**Anchor QEA Memorandum
“Response to U.S. Army Corp of Engineers’ Request
for Additional Information”**

To: Erin Legge, U.S. Army Corps of Engineers **Date:** March 28, 2013
From: Heather Griffin, City of Everett
Heather Page, Anchor QEA, LLC
Re: Kimberly Clark DWO Project (NWS-2000-34)
Response to U.S. Army Corps of Engineers' Request for Additional Information

Figure 1: Pre-Construction (left) 2001 and Post-Construction (right) 2011 Aerial Photography of Project Site
Depp Water Outfall Beach Repair Project

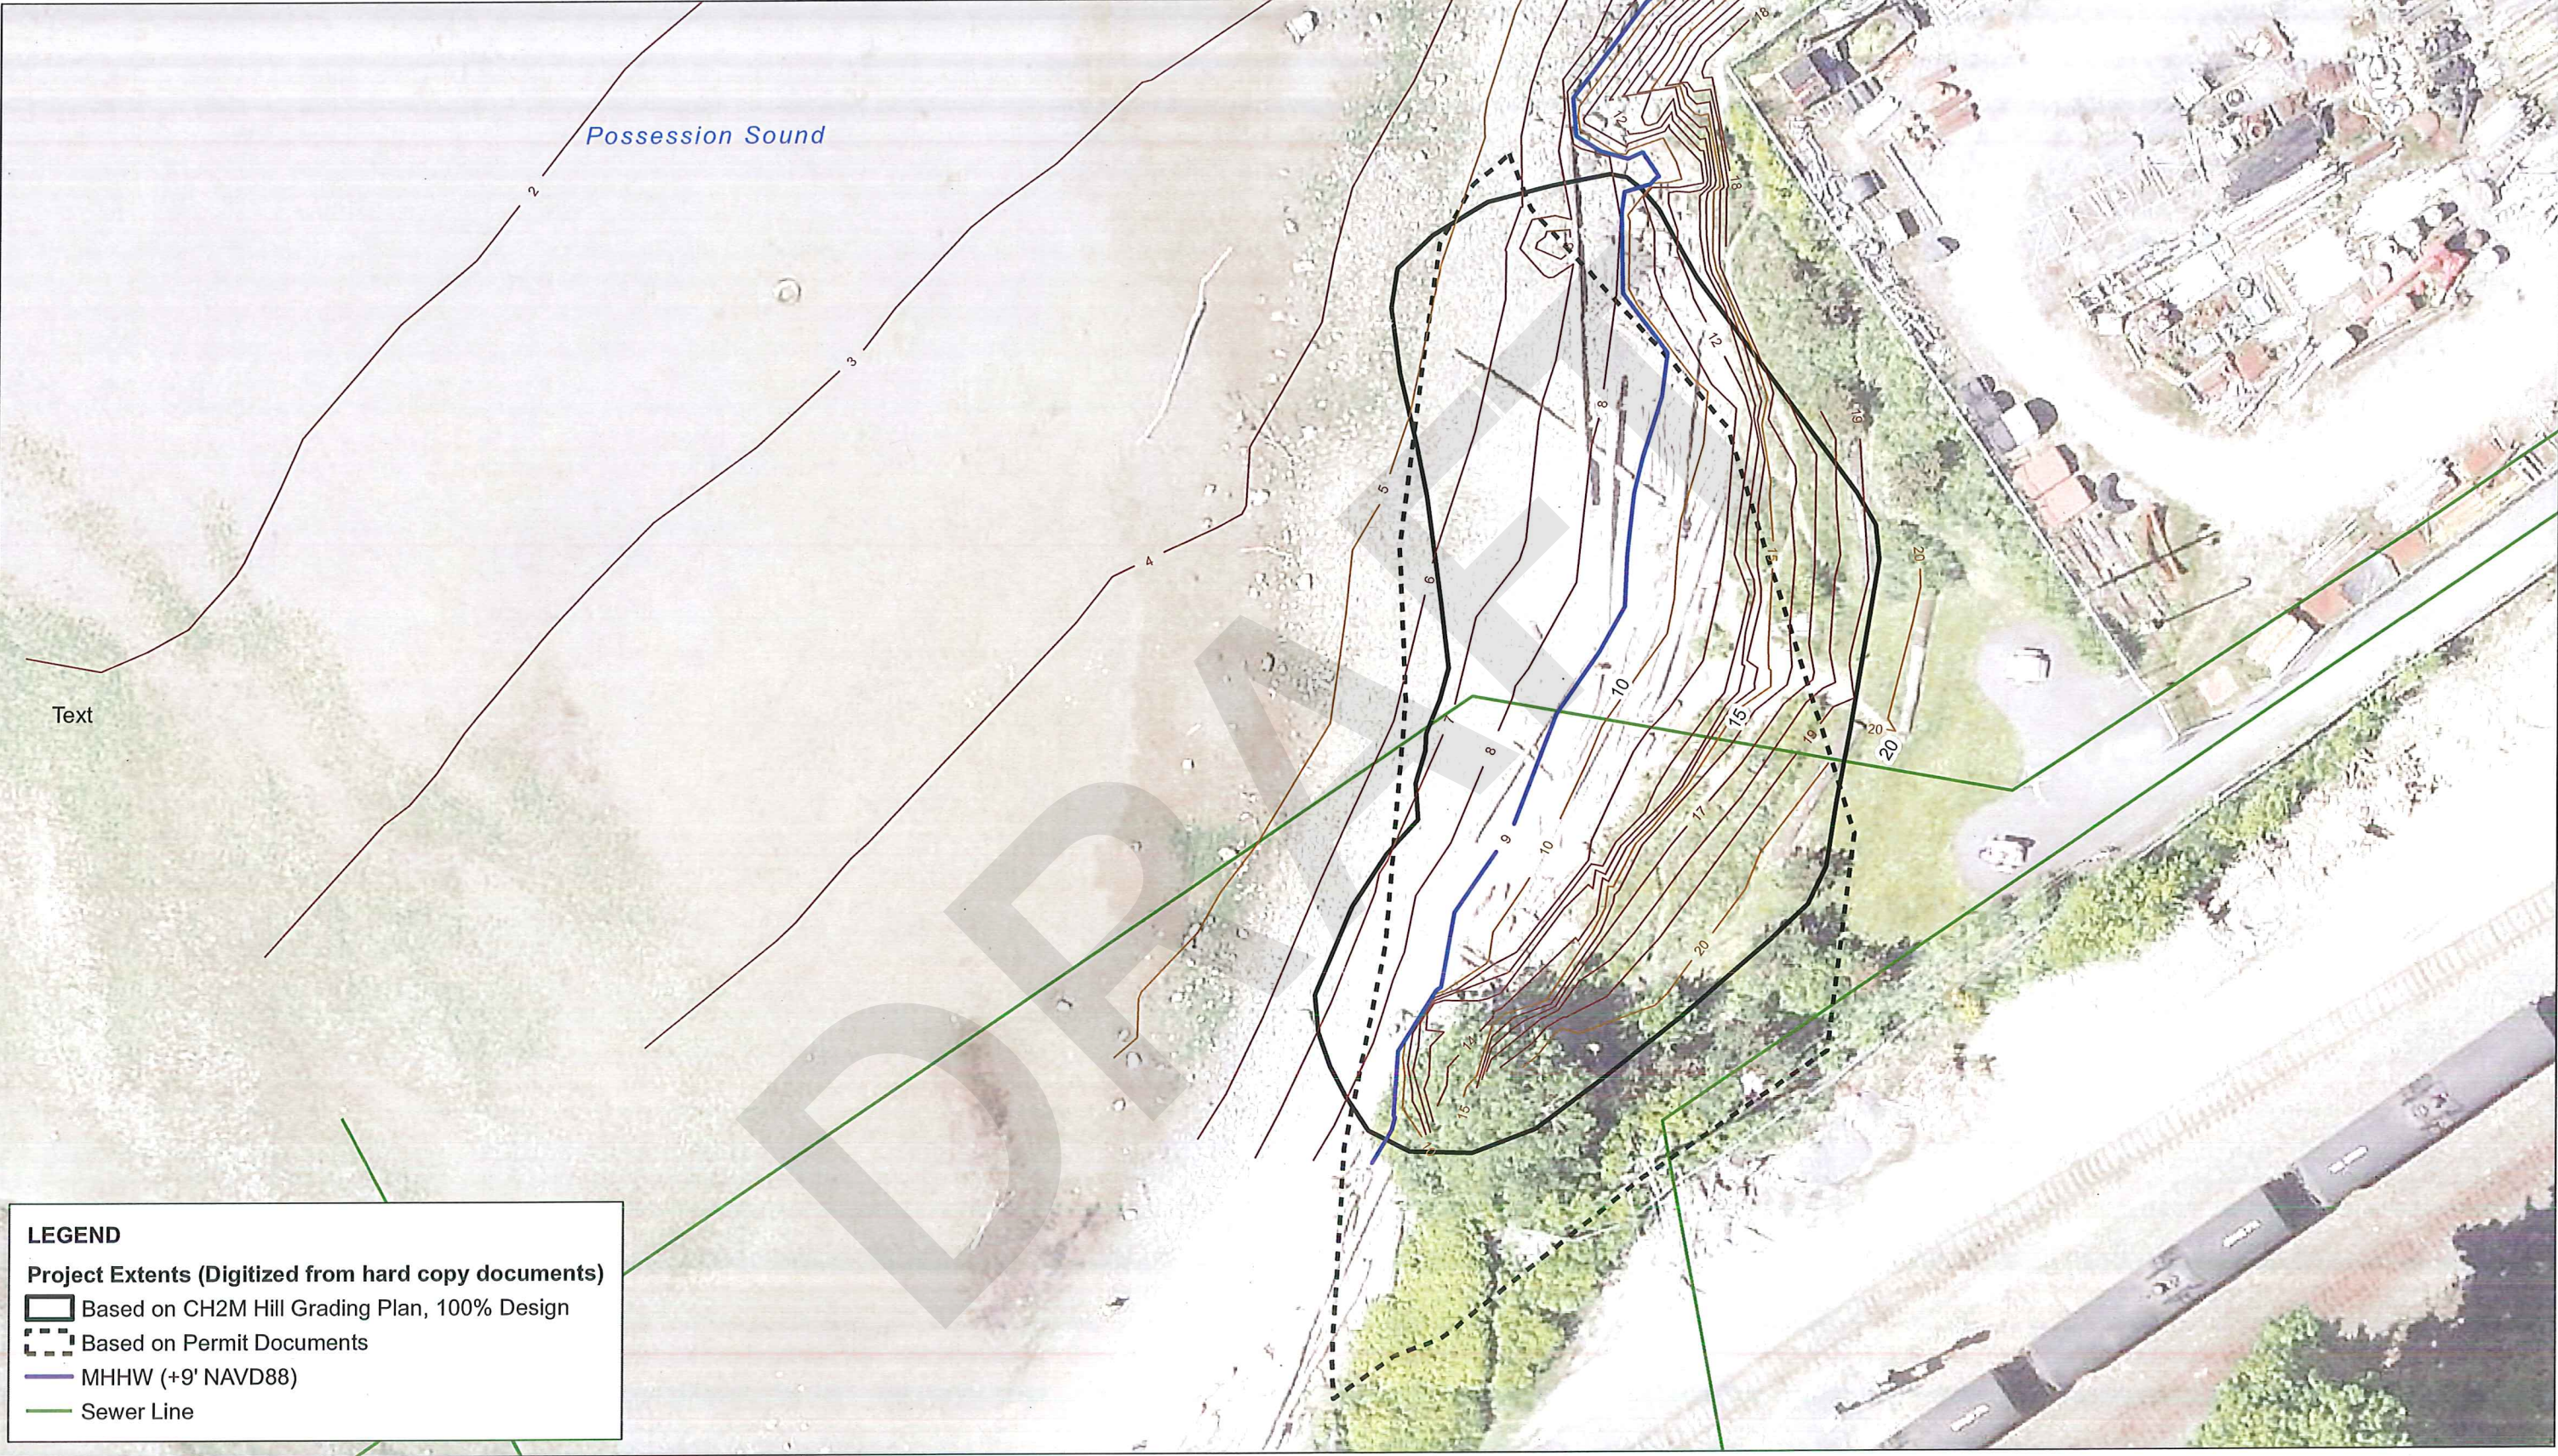
CLEARLY DESCRIBE THE ORIGINAL BEACH RESTORATION, PHASE 1 (KIMBERLY CLARK) AND PHASE 2 (CITY OF EVERETT)

The site was originally uplands and was part of the Port of Everett (Port) as a laydown yard. It extended from the current northwest corner of the Port's laydown area to the southern portion of the project extent (see Figure 1 in Attachment 1).

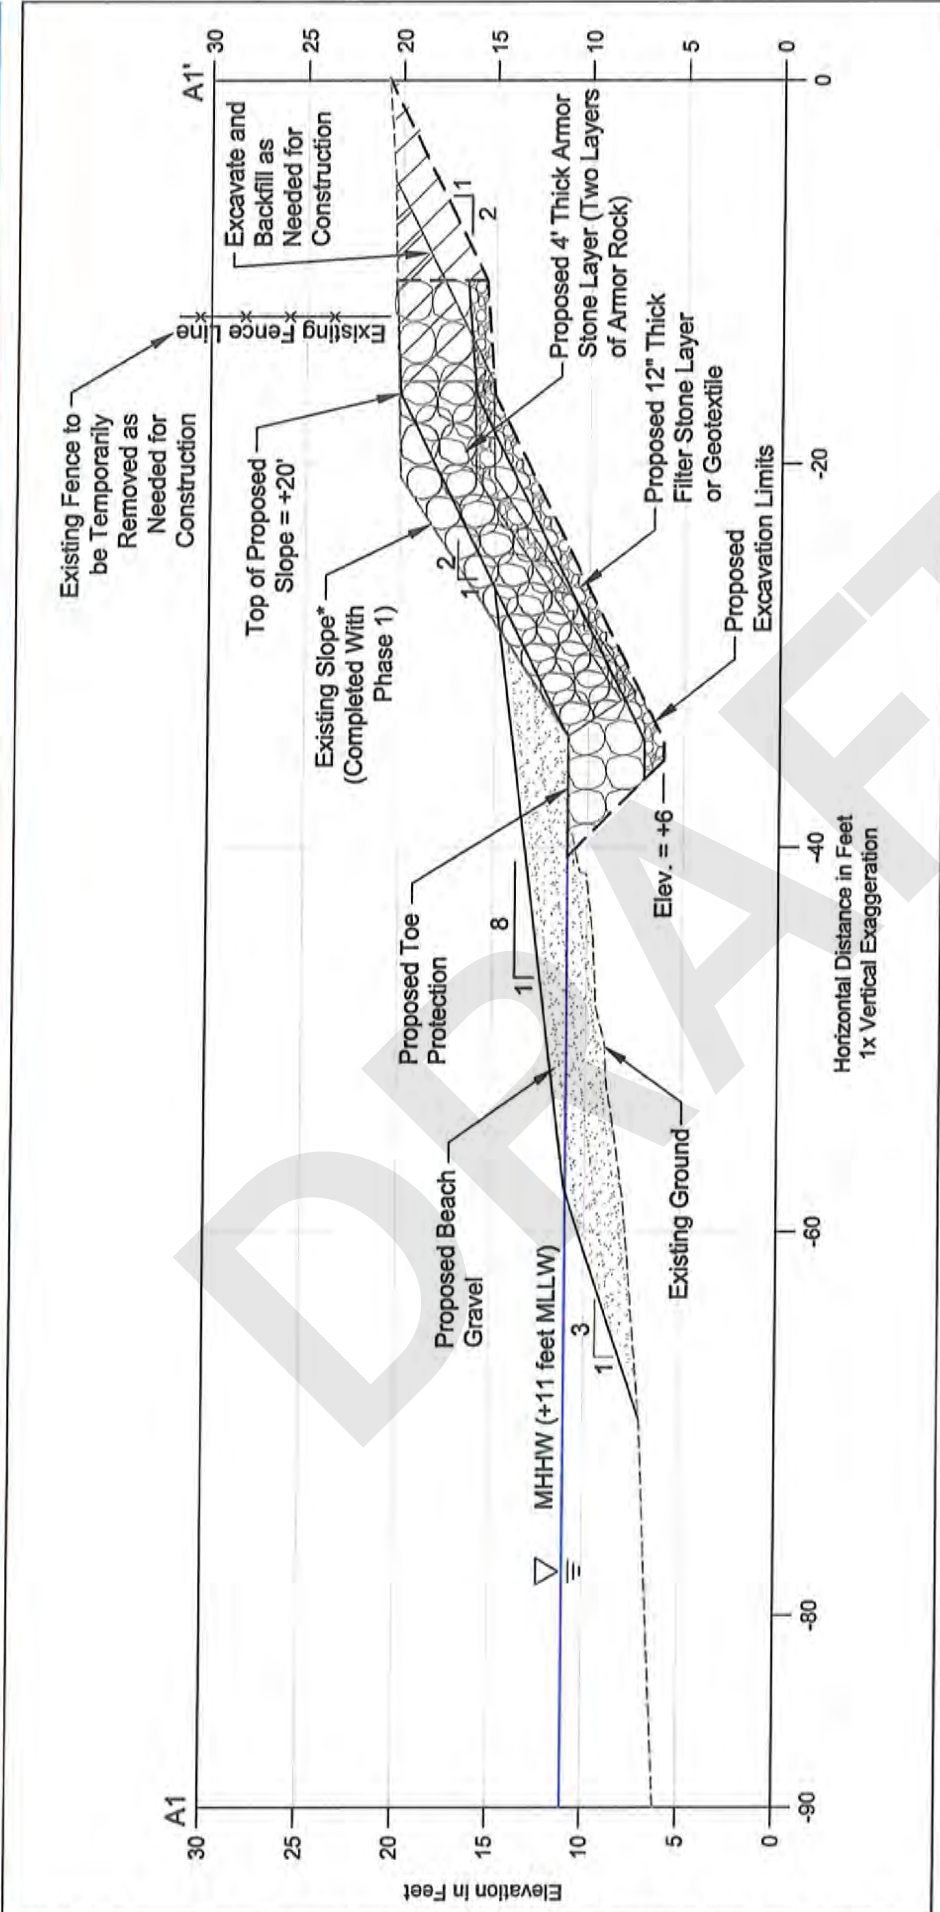
KCDWO Project Phase 1

Phase 1 consisted of armoring the slope immediately adjacent to Port property (1,500 square feet; see Figure 5 in Attachment 1) above the existing MHHW. In addition to the eroded condition of the beach described above in "Original Beach Restoration," a storm on January 26, 2012, destabilized this area and threatened the slope's stability. Under the terms of their easement with the Port, KC needed to repair the beach as soon as possible, as further erosion may have led to additional slope destabilization throughout the site and possible property damage to Port property on the north side of the slope.

Approximately 300 cubic yards of armor stone (4 feet thick) and 75 cubic yards of filter stone (1 foot thick) were placed to stabilize the slope. To construct the slope, approximately 400 cubic yards of mixed sand/cobble material and armor stones were excavated and disposed of or reused as appropriate. Prior to construction, State Environmental Policy Act and Shoreline Substantial Development Permit Exemptions were obtained from the City of Everett Planning and Community Development. This project was completed in 4 days in December 2012.

ATTACHMENT 2
REVISED JARPA SHEET 2

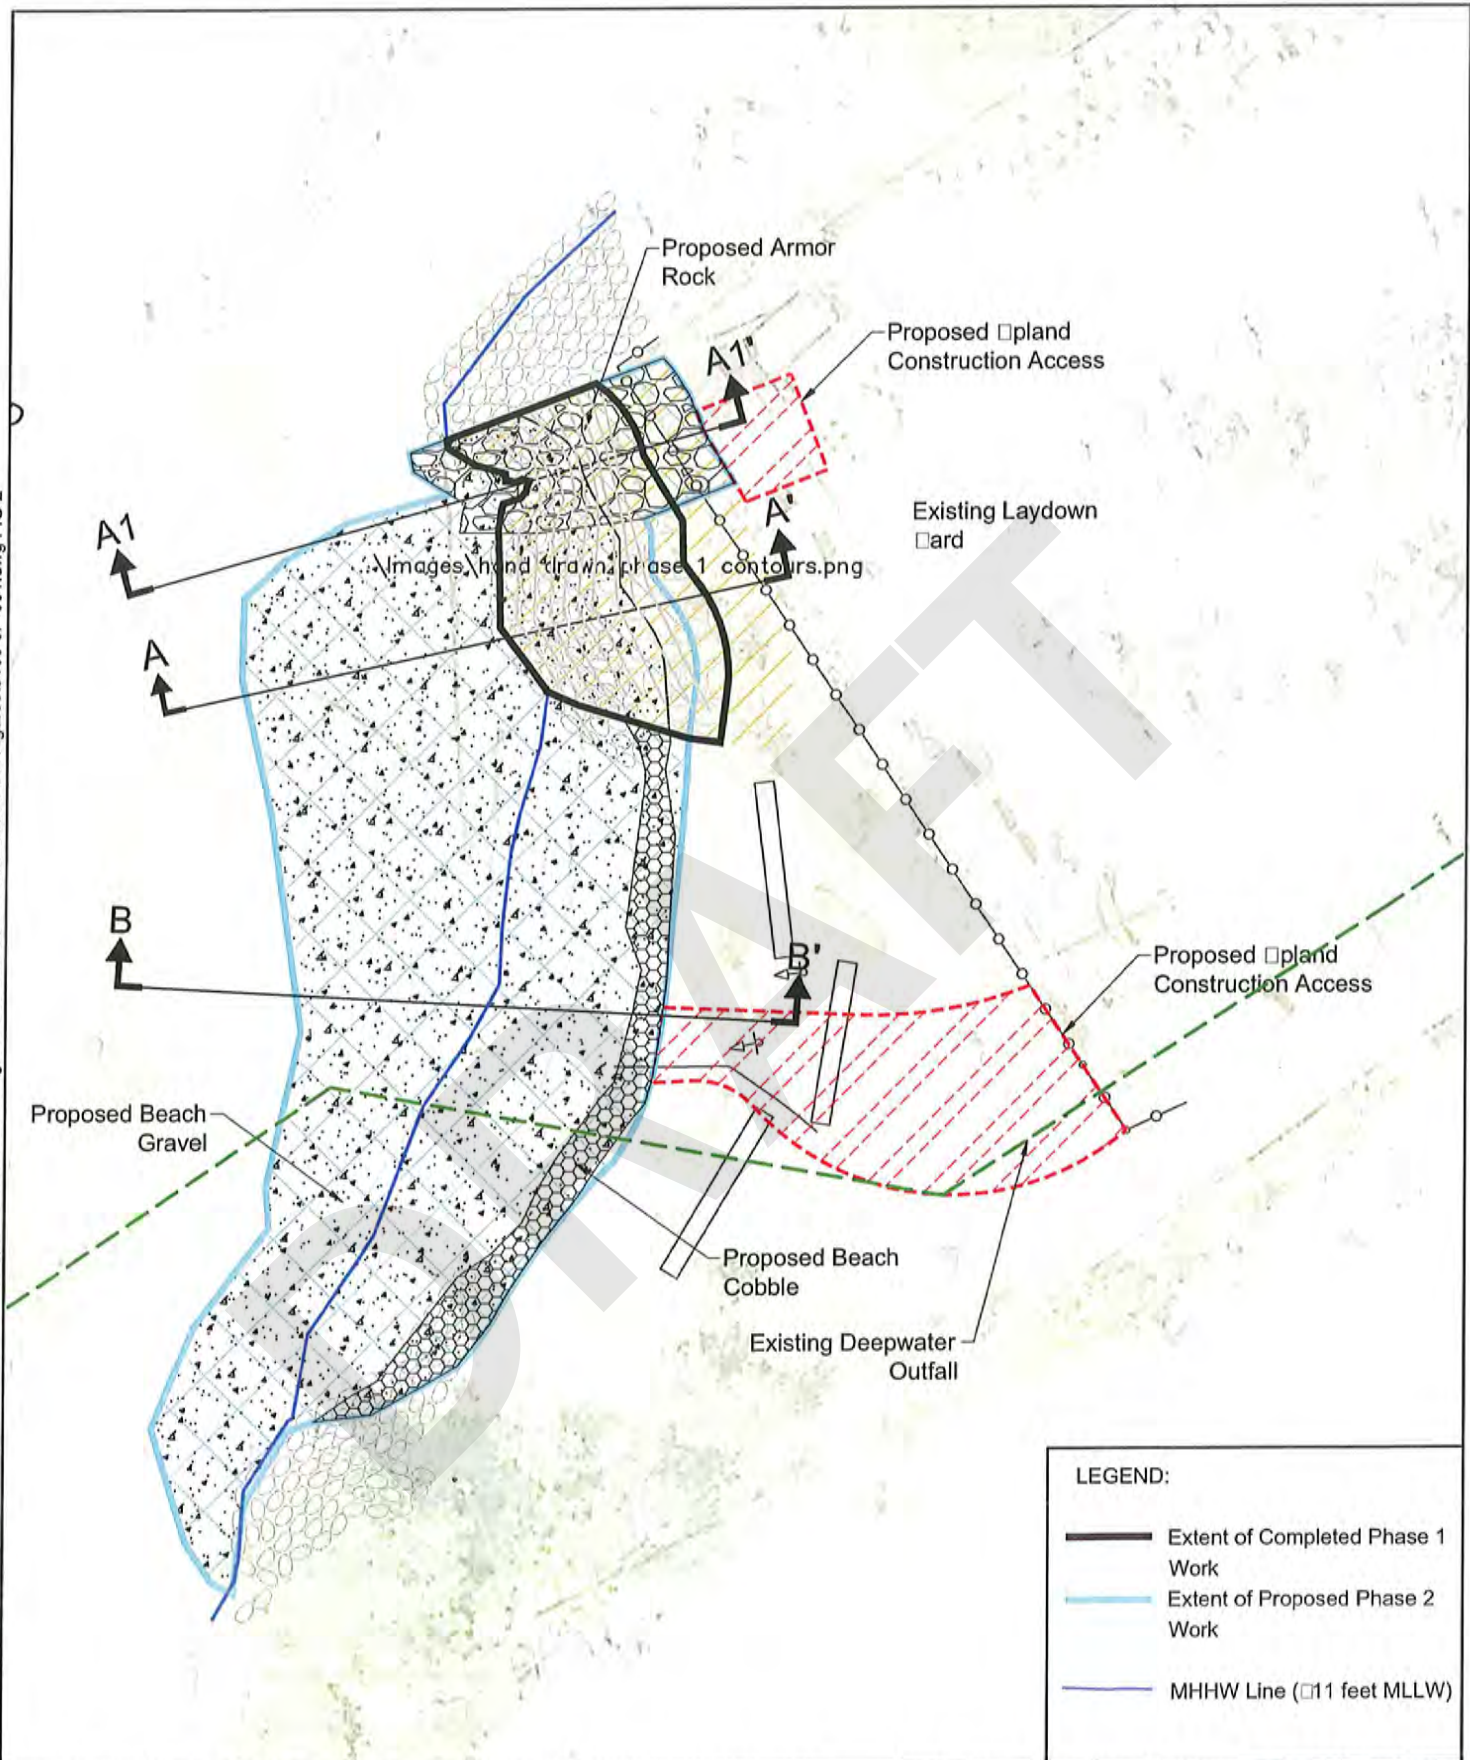
KCDWO Project Phase 2 Overlap with Phase 1

Phase 2 consists of adding additional toe protection to portions of the Phase 1 slope above and below MHHW (see revised Sheet 2 of the Joint Aquatic Resource Permit Application [JARPA] Drawings in Attachment 2). See Figure 6 in Attachment 1 for a cross-section of the overlap between Phase 1 and Phase 2. The toe of the slope from Phase 1 will be extended 50 square feet beyond MHHW to the extent required to build a stable rock revetment to stabilize that area. The revetment would also be modified from the 1.5H:1V slope for the Phase 1 construction, to achieve a 2H:1V slope for the final Phase 2 construction. Please see the JARPA submitted to USACE for a complete description of Phase 2 (City of Everett 2012).

The project area and vicinity were excavated in late 2003 to place an offshore outfall for KC and the City (outfall shown on revised Sheet 2 of the JARPA Drawings in Attachment 2). A temporary trestle was built to aid in the placement of the offshore outfall, which extended from its land connection at the project site to the southwest. In February 2004, following construction of the outfall, the site was re-graded and filled to create a pocket beach. The temporary pier was removed and the shoreline was cut back from a straight shoreline to a curved shoreline. Immediately after construction, the beach sand began eroding due to impacts from storm wave action (as described above in "Original Beach Restoration"), forming a vertical scarp along the shoreline. A month following construction, the beach
